To: Eastleigh Borough Council Author: Matt Podesta – Principal Engineer
Approved: Eddy Goldsmith – Technical Director
Project Name: One Horton Heath, Upper Acre
Project No. 333701779 Date: 30th January 2026

Reference: 333701779-XX-XX-TN-Y-1001-P02 – One Horton Heath, Upper Acre

Figure 1 Upper Acre site view from east

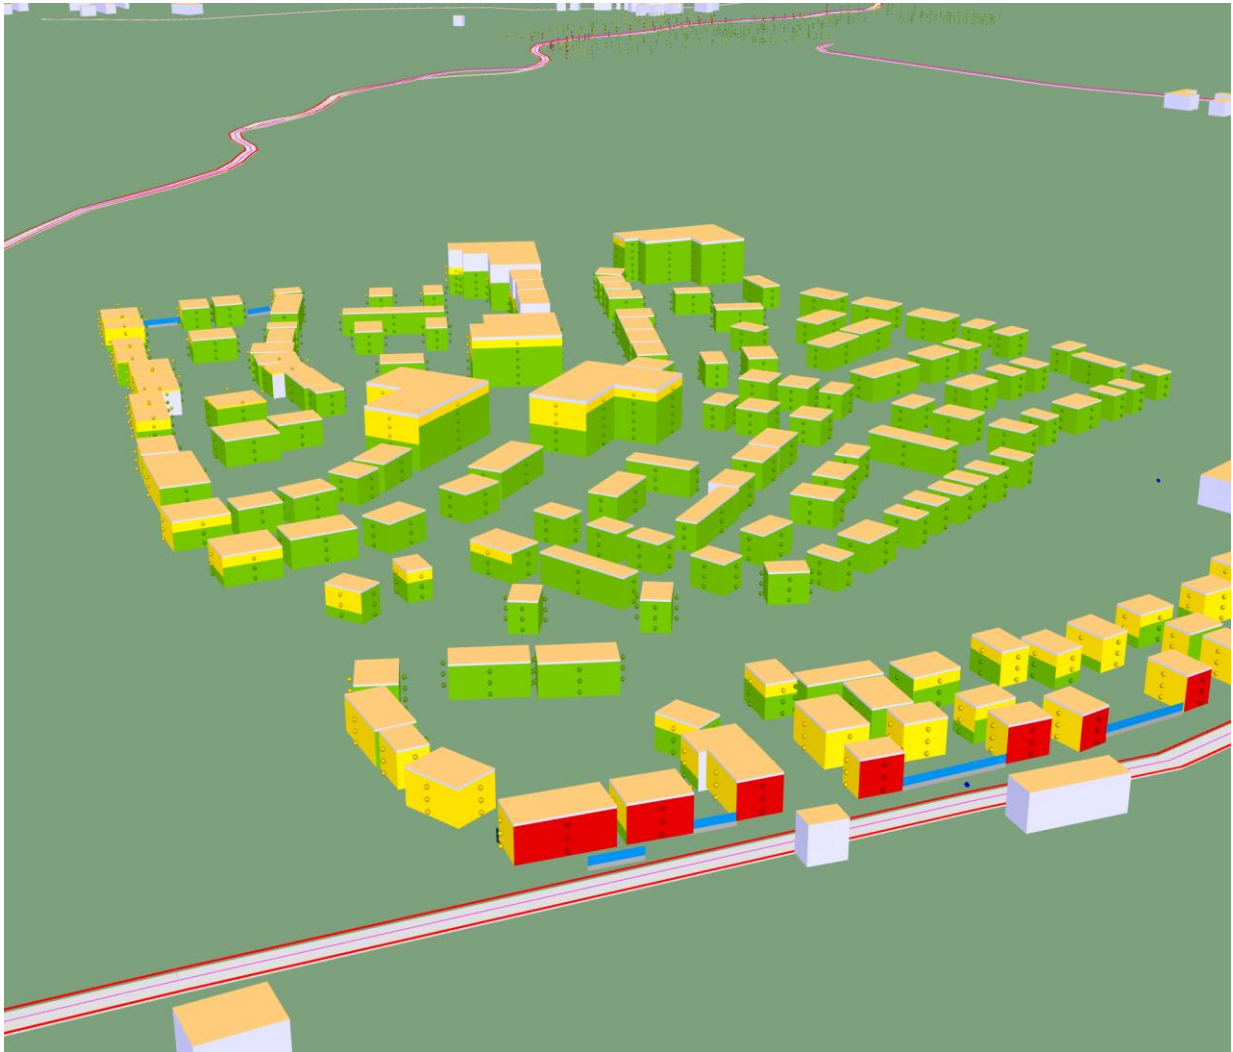
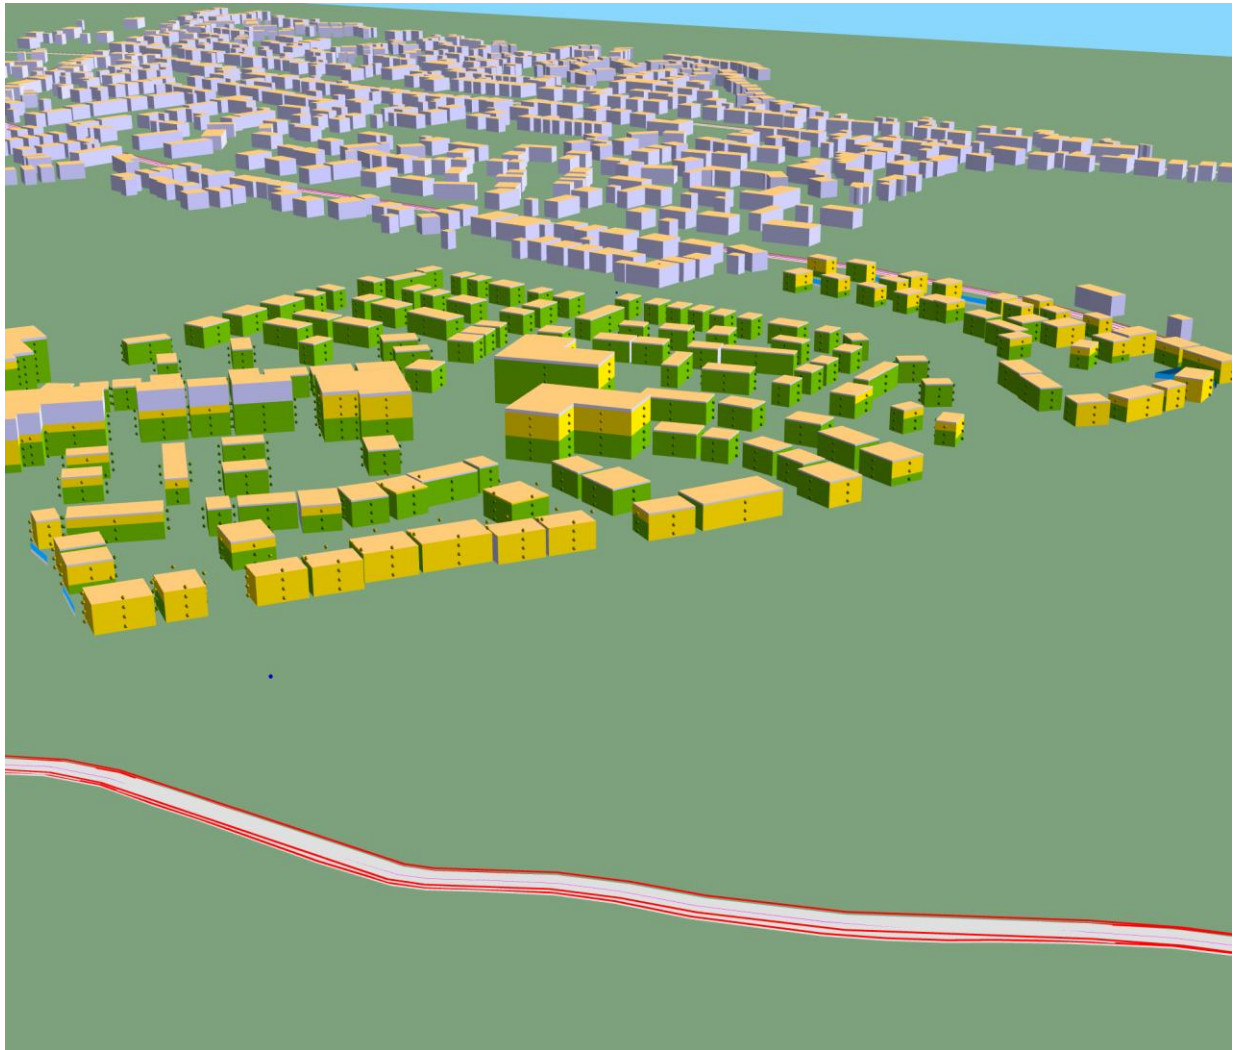
[In relation to Upper Acre] Can you please explain why the façade not facing the closest road requires a higher level of mitigation than the façade facing the closest road ? As per in the below image. Why is the yellow façade not facing the closest road?

The road running through the site is a minor link road for which traffic flows and speeds are expected to be relatively low. No specific traffic data has been provided for this road link has therefore not been modelled. Noise from this link is expected to be negligible.

The reason for the specifications as they are shown on the apartment buildings is due to these being taller than the surrounding building types and, therefore, the upper floors being exposed to noise from Burnetts Road and The Avenue (main OHH link road), this is more clearly illustrated in the 3-dimensional views of the site below.
